## ORIGINATION FORM

Proposed Revisions to a Standard Plans Index  
(Please provide all information — Incomplete forms will be returned)

Index Number: 450-199  
Sheet Number (s): Sheet 1  
Index Title: PRESTRESSED I-BEAMS BUILD-UP & DEF  
DATA

**Summary of the changes:**

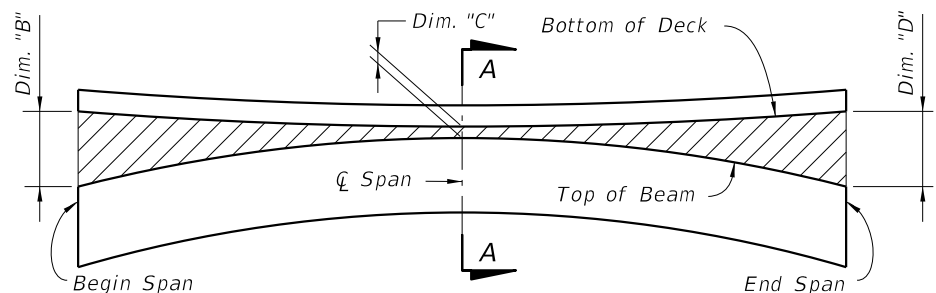
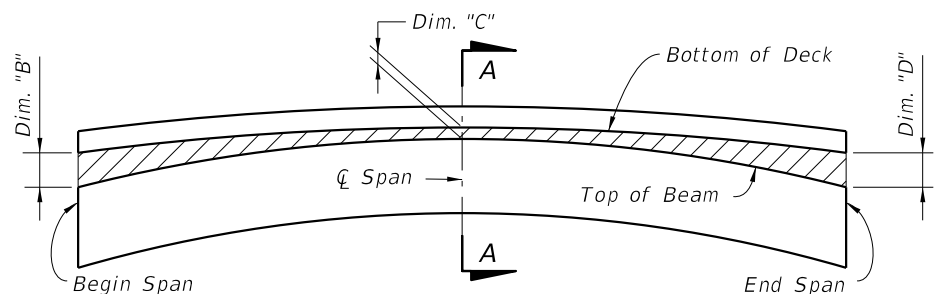
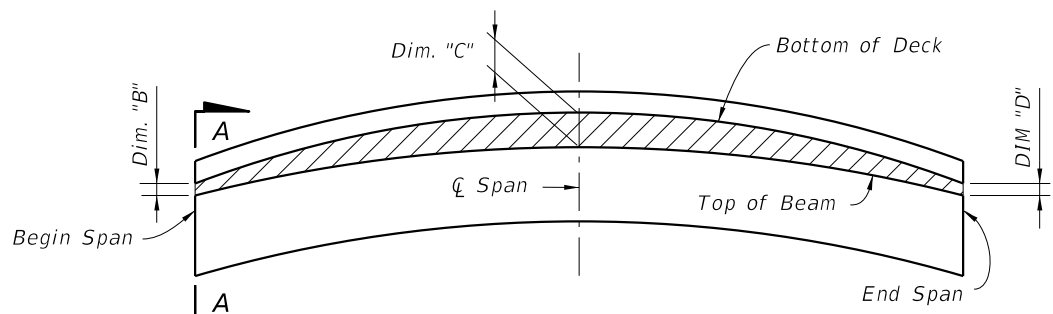
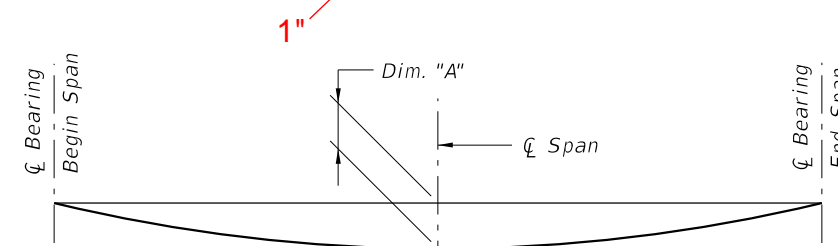
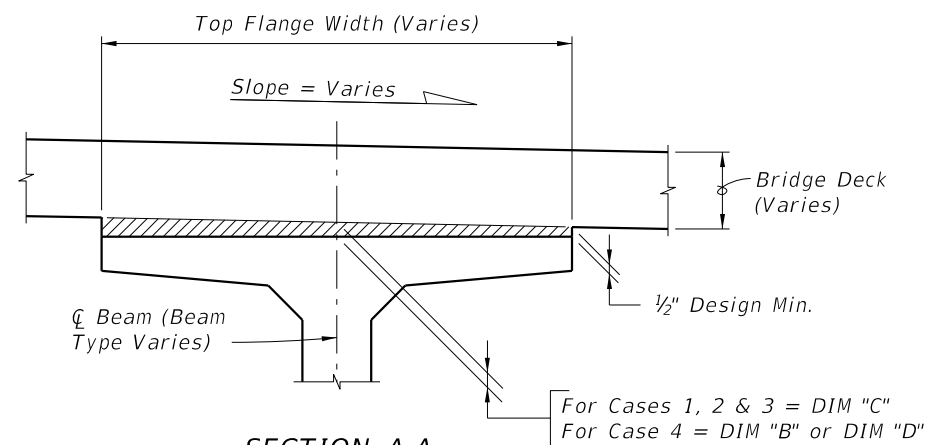
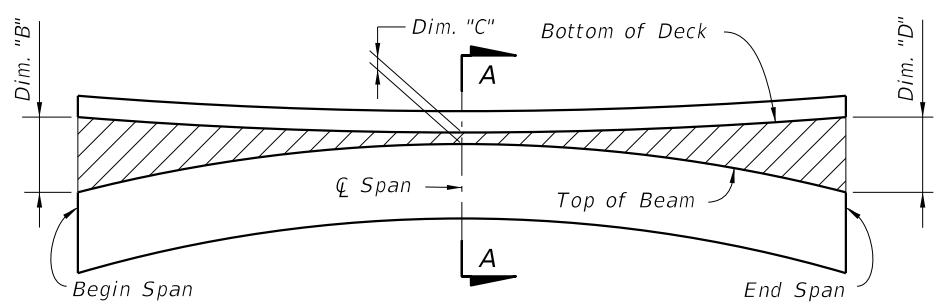
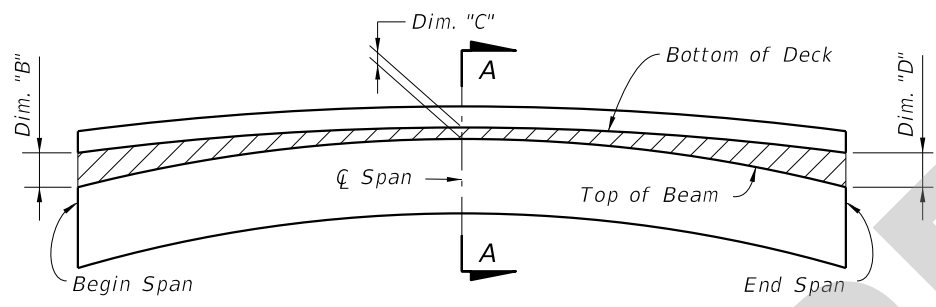
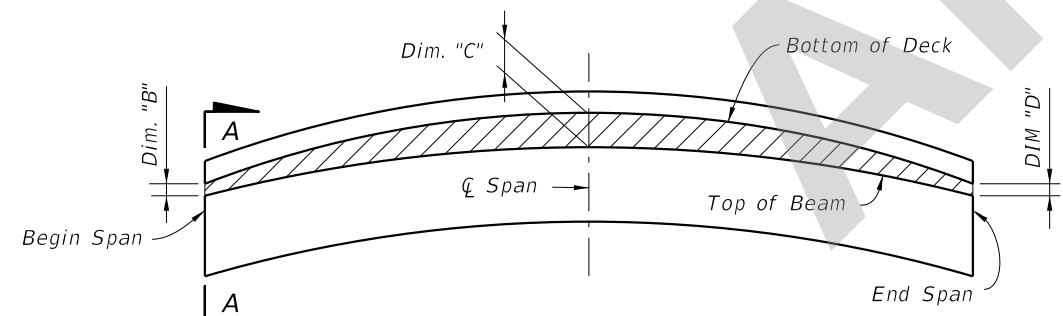
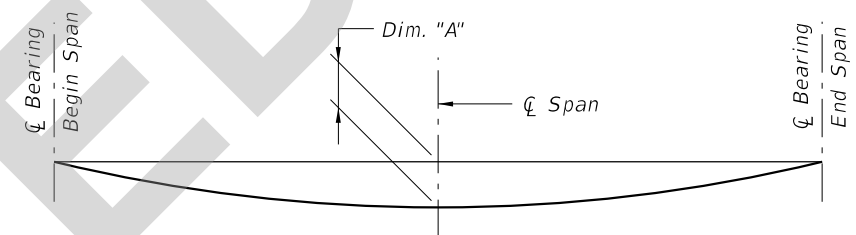
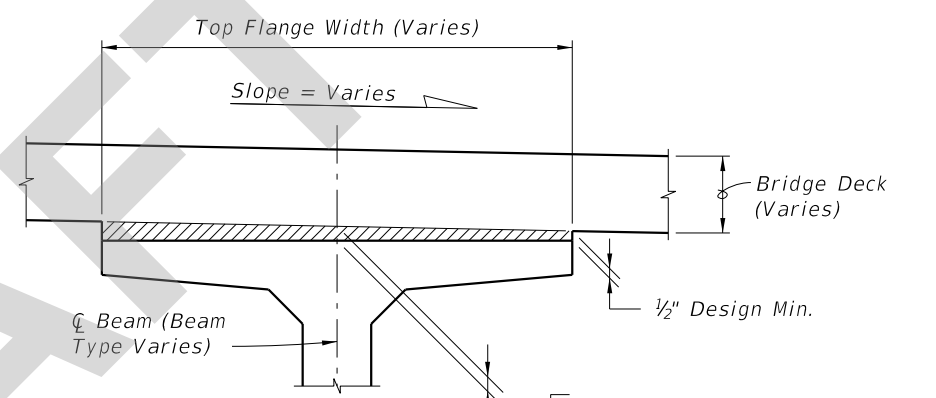
Change the camber tolerance to 1" from 1/2".

The build-up values given in the Data Table\* are based on theoretical beam cambers. The Contractor shall monitor beam cambers for the purpose of predicting camber values at the time of the deck pour. If the predicted cambers based on field measurements differ more than  $\pm 1/2$ " from the theoretical "Net Beam Camber @ 120 Days" shown in the Data Table\*, obtain approval from the Engineer to modify the build-up dimensions as required. When the measured beam cambers create a conflict with the bottom mat of deck steel, notify the Engineer a minimum of 21 days prior to casting.

The build-up values given in the Data Table\* are based on theoretical beam cambers. The Contractor shall monitor beam cambers for the purpose of predicting camber values at the time of the deck pour. If the predicted cambers based on field measurements differ more than +/- 1" from the theoretical "Net Beam Camber @ 120 Days" shown in the Data Table\*, obtain approval from the Engineer to modify the build-up dimensions as required. When the measured beam cambers create a conflict with the bottom mat of deck steel, notify the Engineer a minimum of 21 days prior to casting.
